10/13/95	ADDENDUM 1
DATE	REVISION
STATE OF HAWAII DEPARTMENT OF TRANSPORTATION HIGHWAYS DIVISION ROOF WALKWAYS COMMON WORK H-3 FINISH (UNIT III) FAIP NO. I-H3-1(75), UNIT III T.K. TUNNEL/ACCESS ROADS SCALE: 1" = 20' DATE: JUN 1995	
SHEET NO. 7A1	OF 5 SHEETS

STATE OF HAWAII
DEPARTMENT OF TRANSPORTATION
HIGHWAYS DIVISION
**ACCESS OPENING SAFETY
RAILING — HALAWA**
COMMON WORK
H-3 FINISH (UNIT III)
FAIP NO. I-H3-I(75), UNIT III
T.K. TUNNEL/ACCESS ROADS
SCALE: NONE
DATE: JUN 1995
SHEET NO. 7SI OF 6 SHEETS

POTABLE WATER TANK

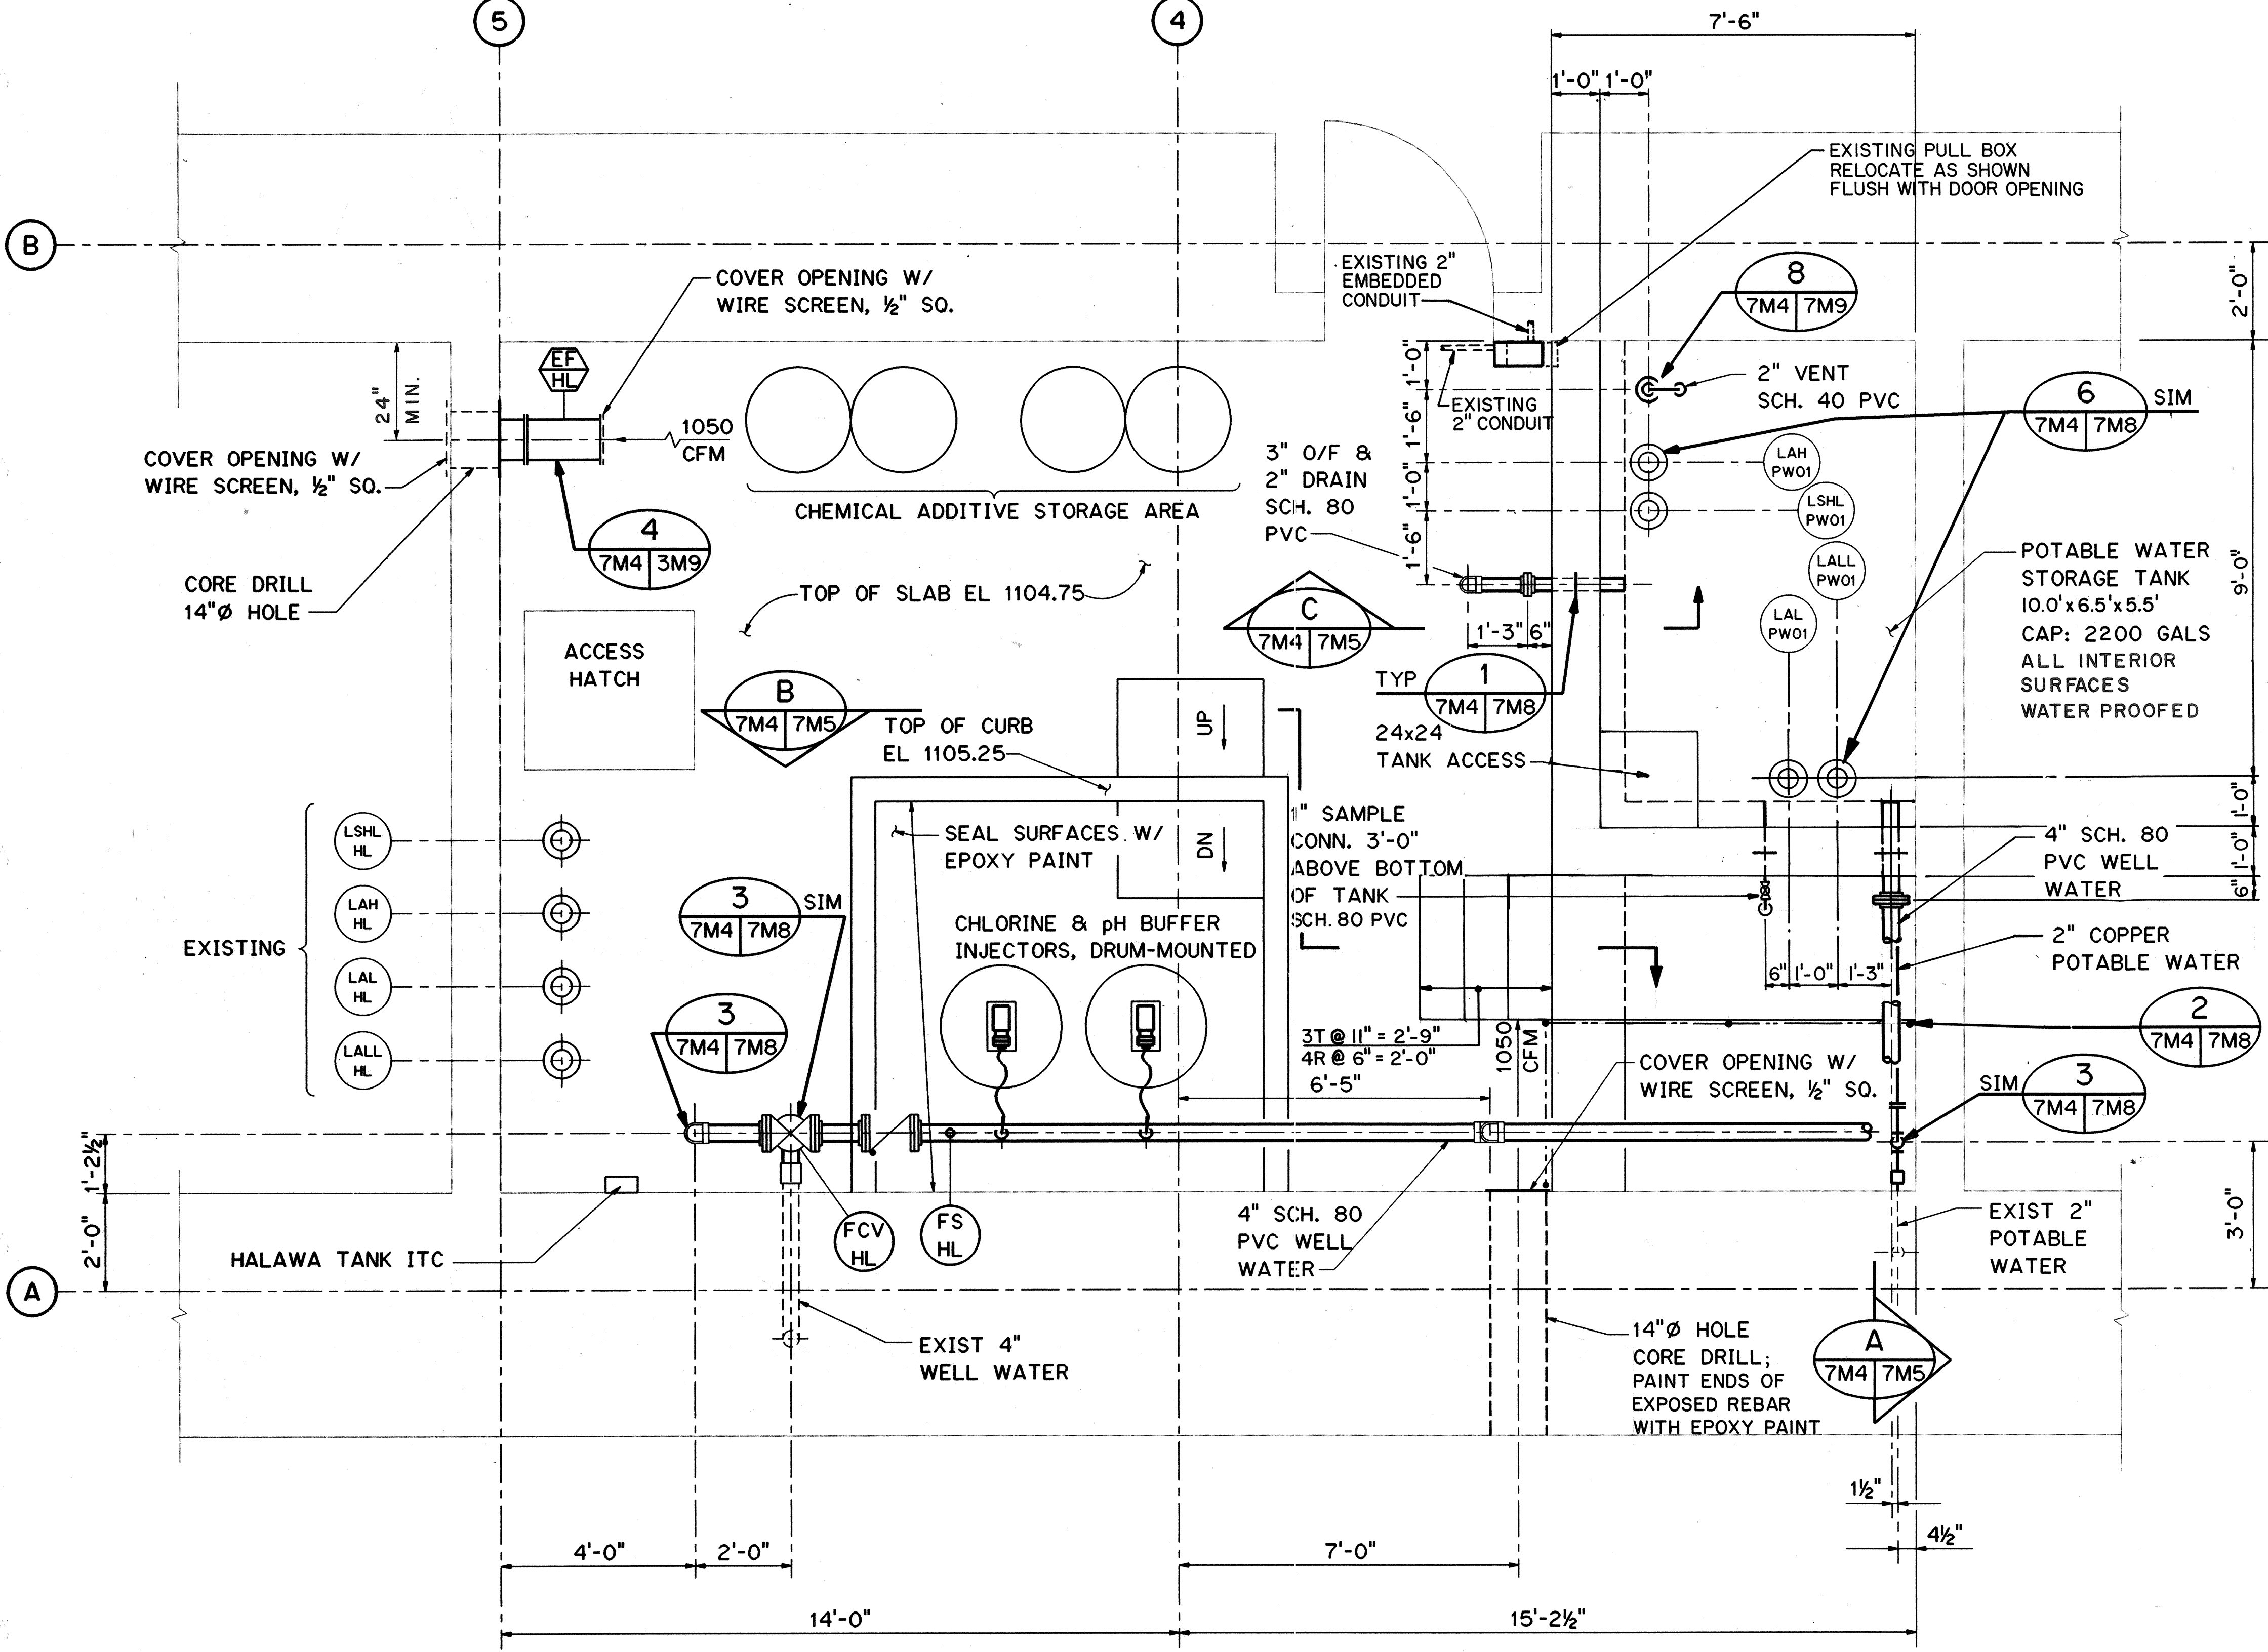
DATE	REVISION
2/3/97	DCN 75-011: REVISED WATER TANK DIM. AND RELOCATED PULL BOX PER RESPONSE TO RFI # 4097-177
10/13/95	ADDENDUM 1
DATE	REVISION
DEPARTMENT OF TRANSPORTATION HIGHWAYS DIVISION HALAWA POTABLE WATER TREATMENT - PLAN COMMON WORK H-3 FINISH (UNIT III) FAIP NO. I-H3-1(75), UNIT III T.K. TUNNEL/ACCESS ROADS SCALE: 1/2" = 1'-0" DATE: JUN 1995 SHEET NO. 7M4 OF 16 SHEETS

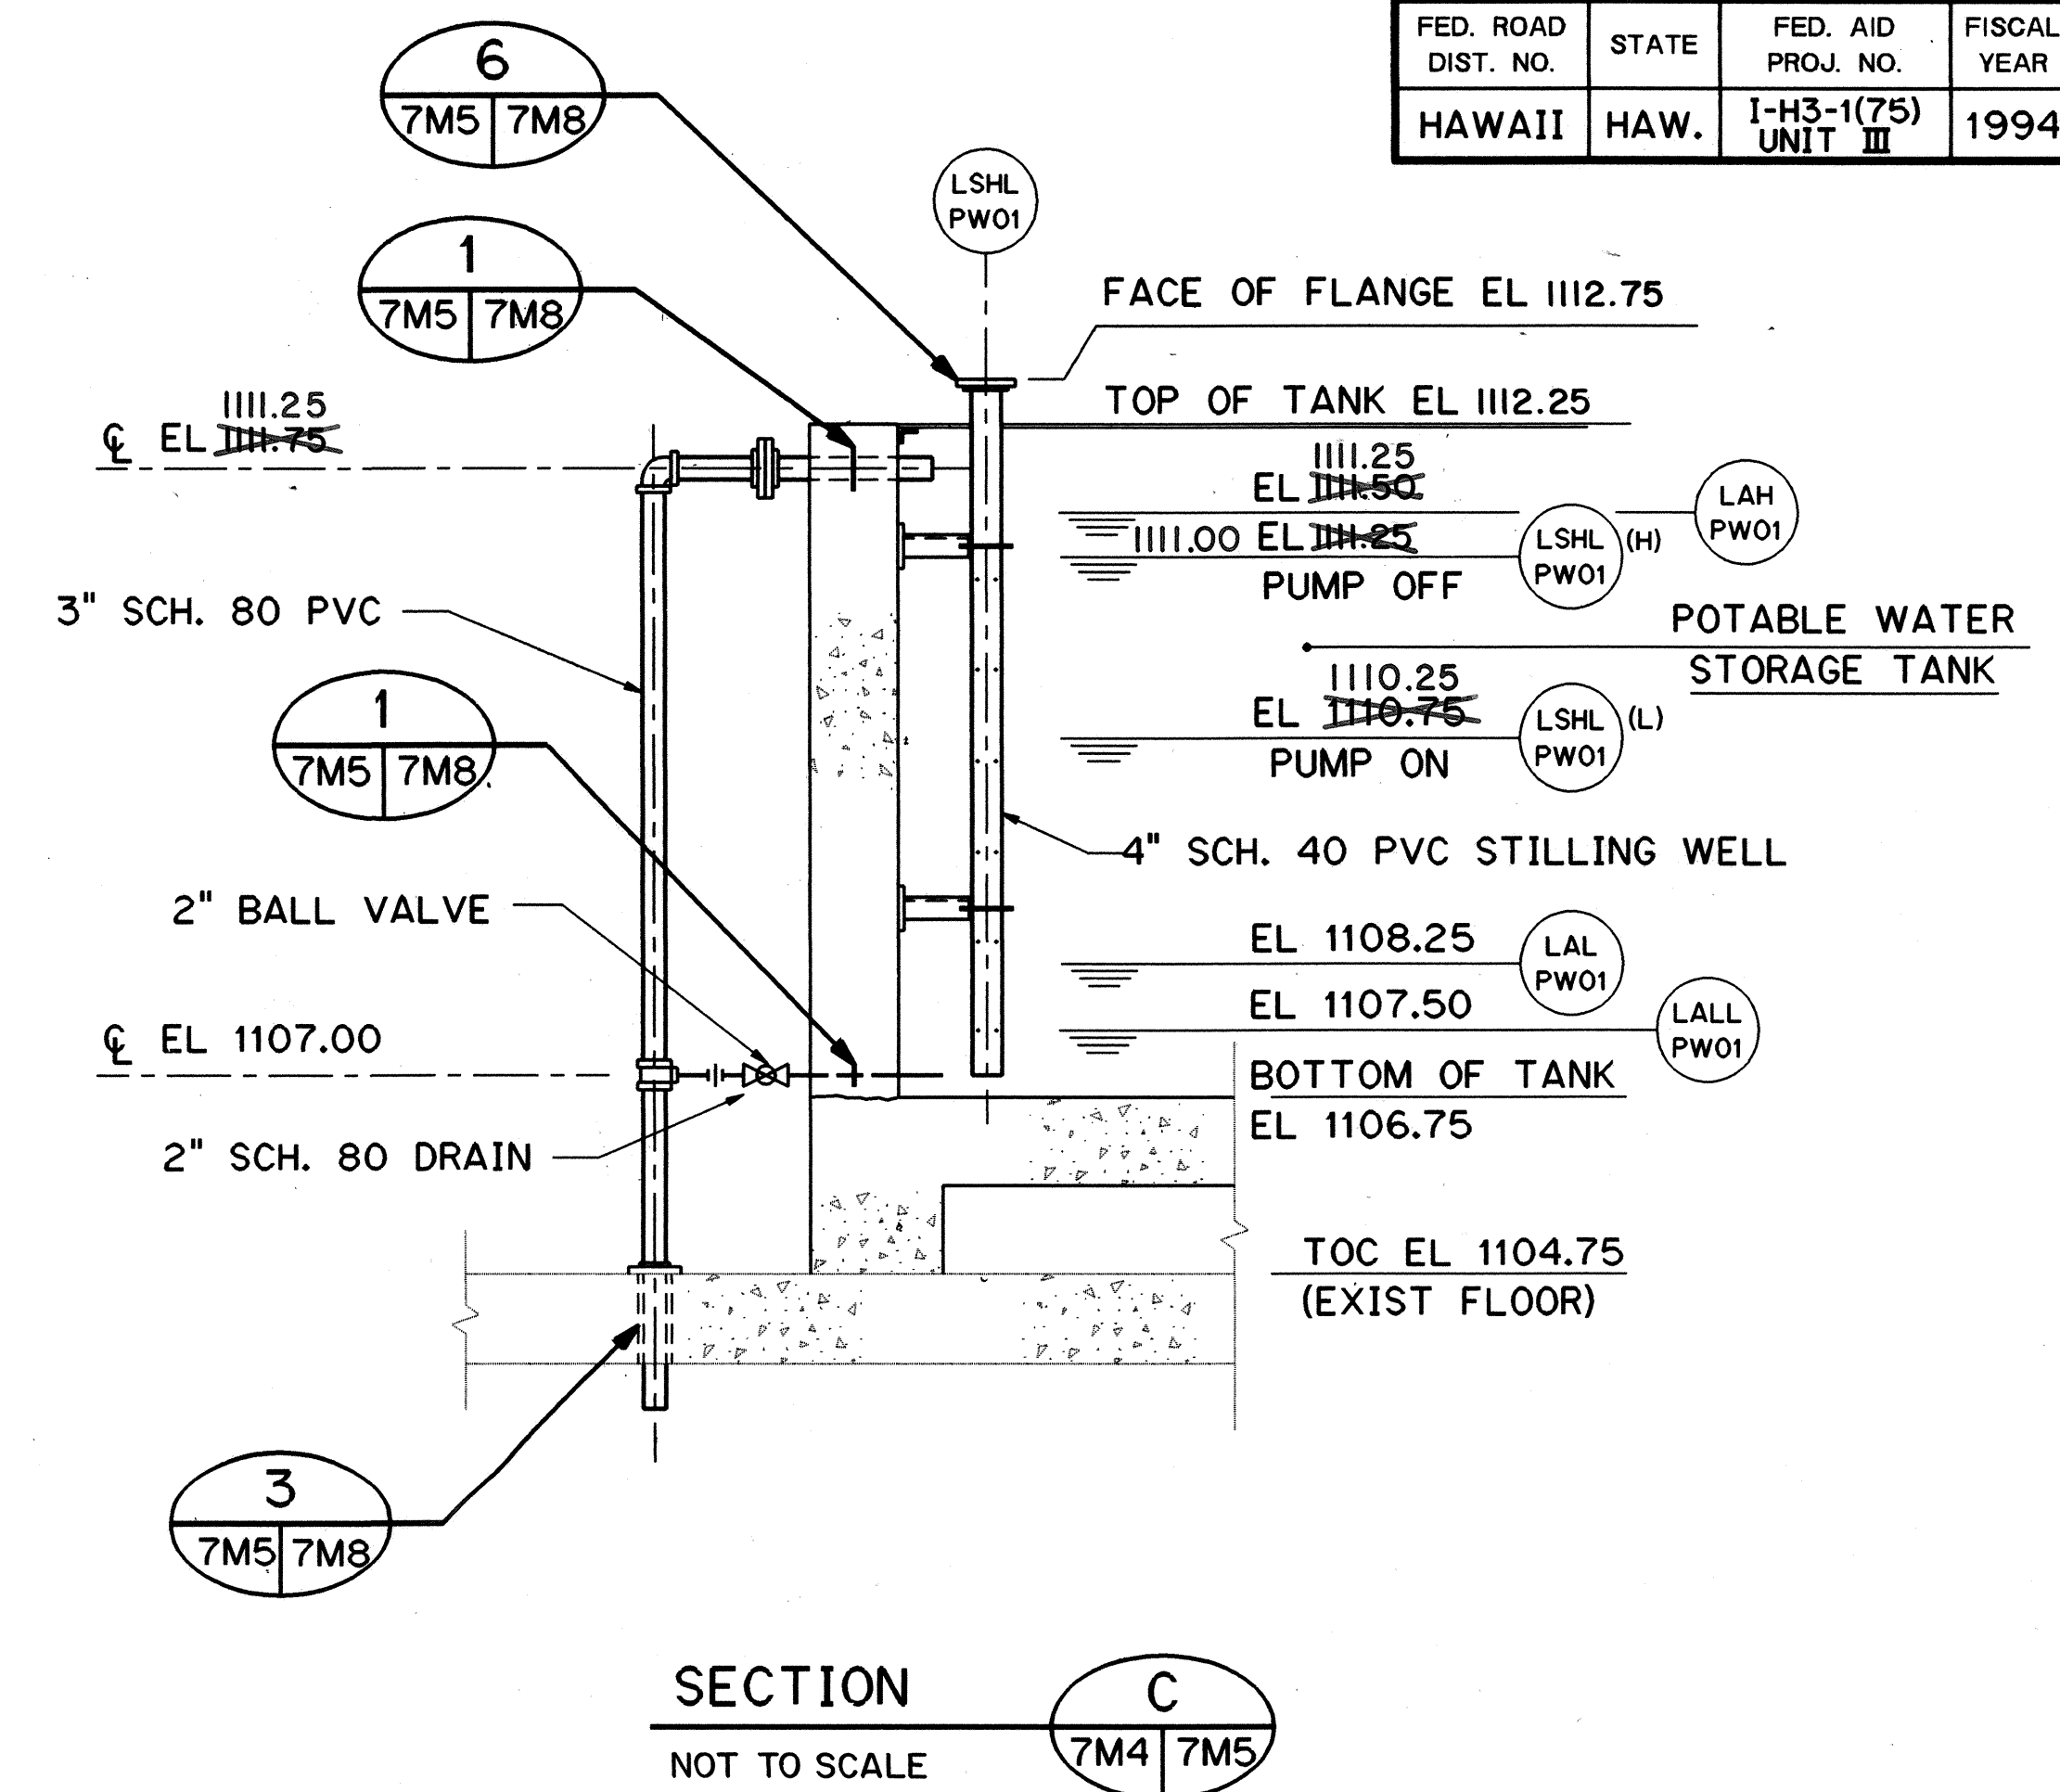
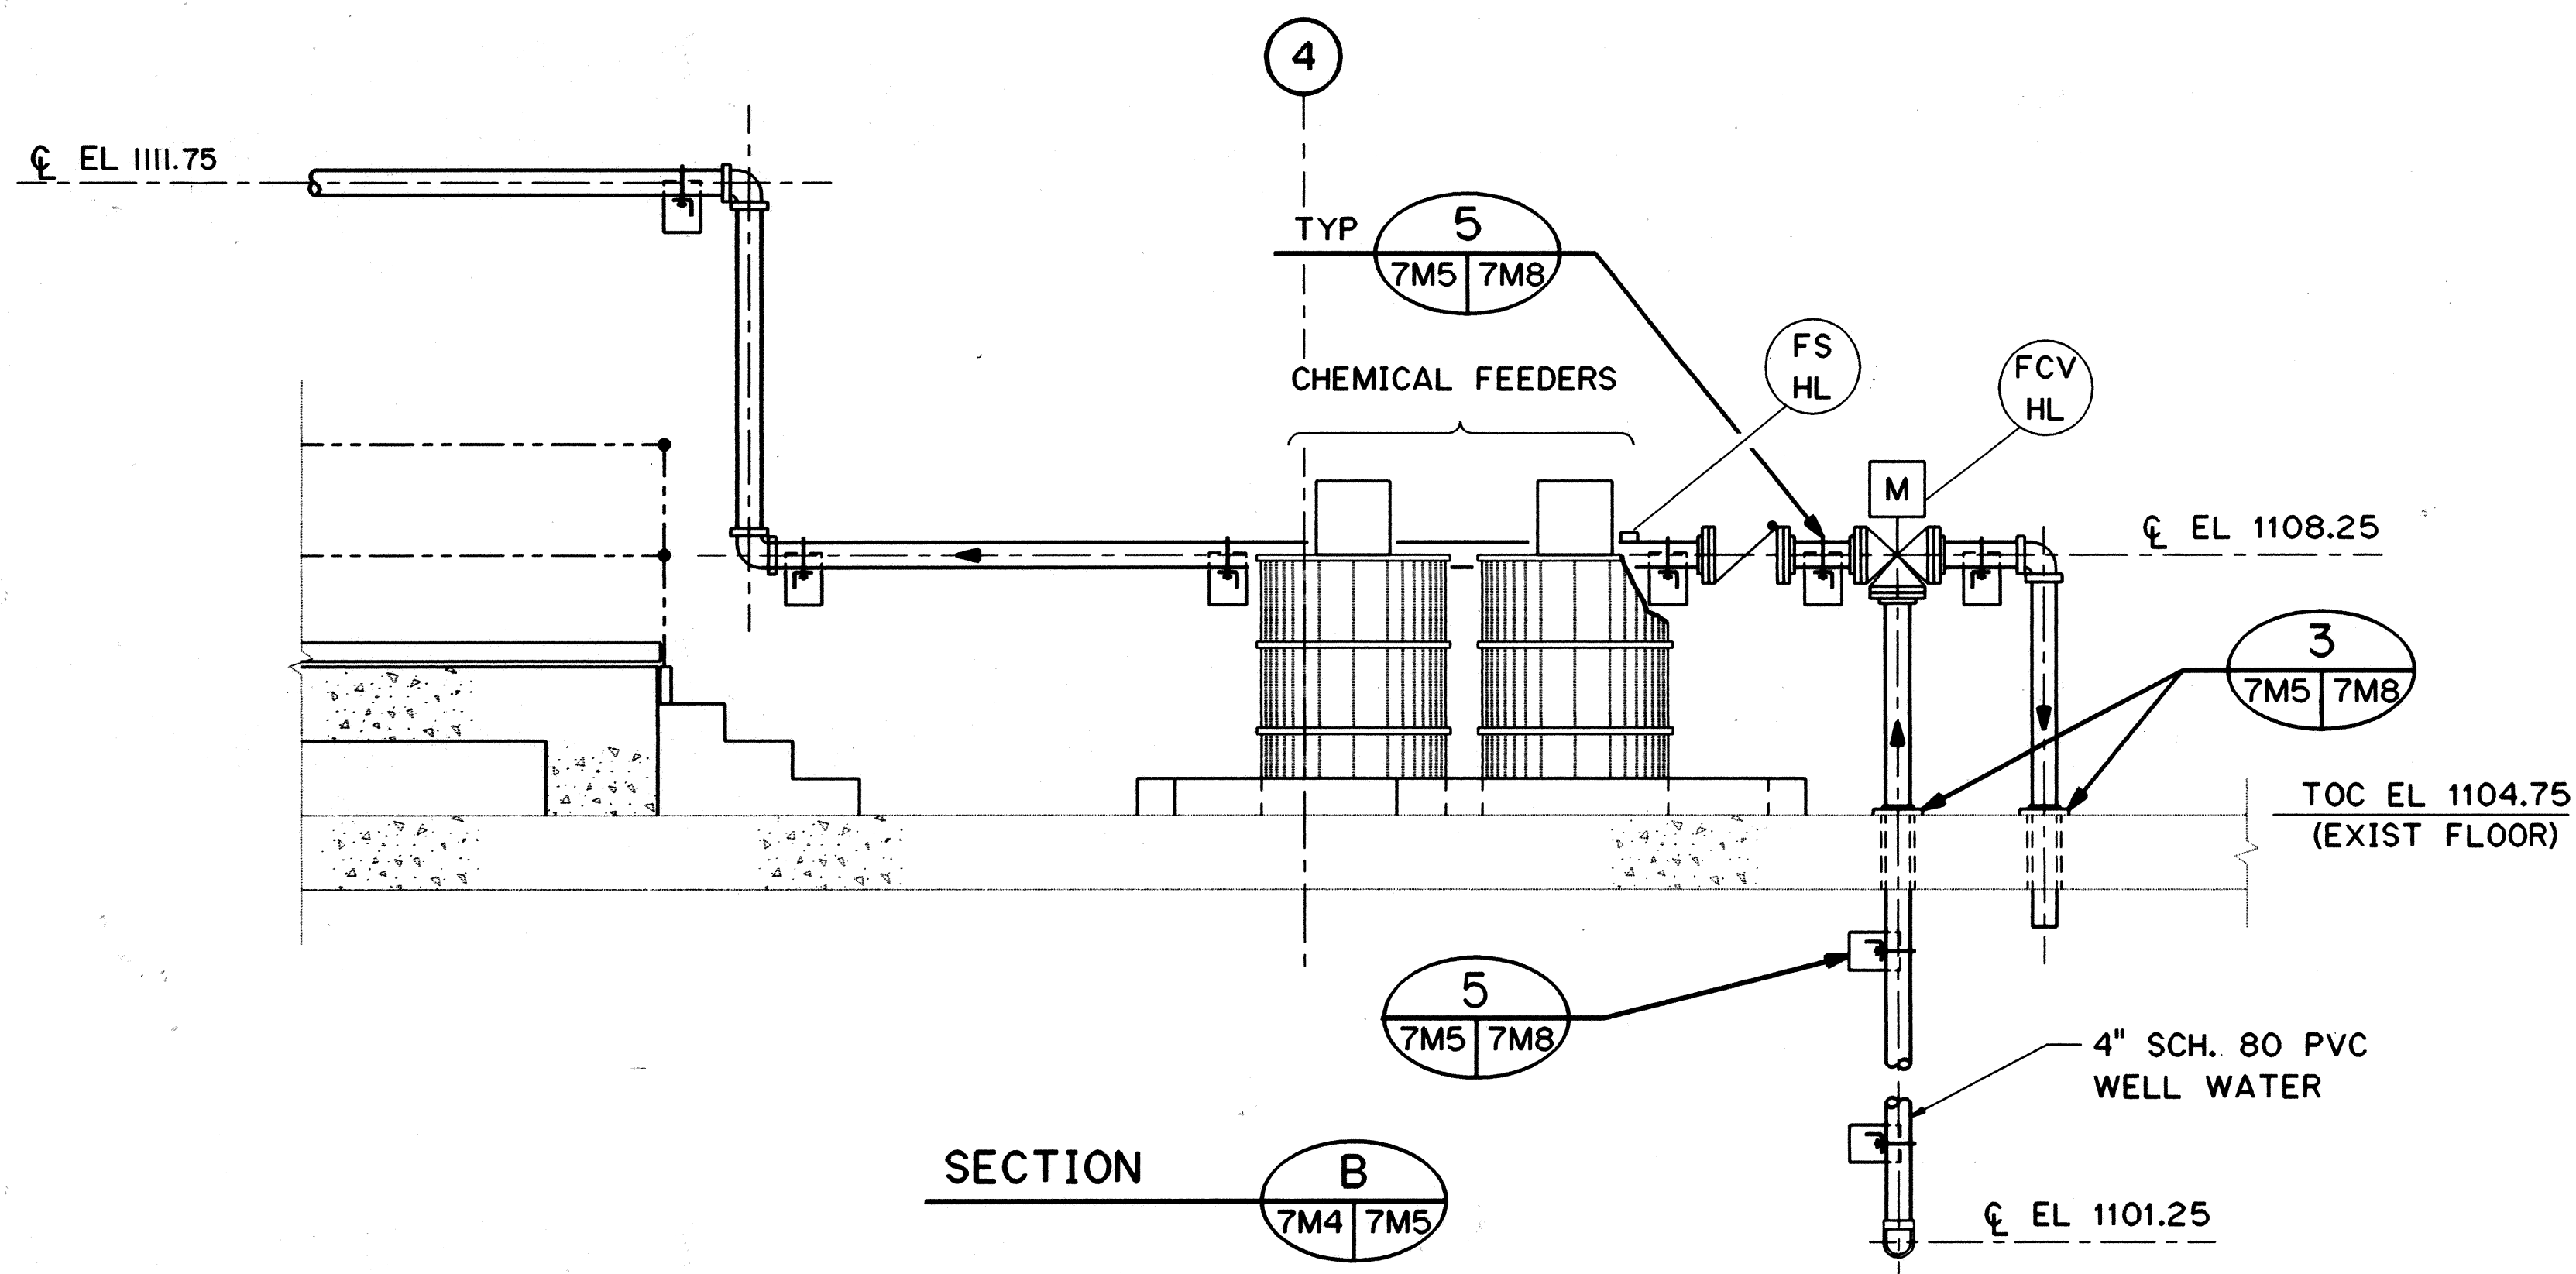
2/3/97	DCN 75-011: REVISED PIPING AND LEVEL SWITCH ELEVATIONS PER RESPONSE TO RFI # 4097-177
10/27/95	ADDENDUM 2- CHANGED PIPE SUPT. DET. 1 SIM. TO DETAIL 5 IN SECT. B
DATE	REVISION
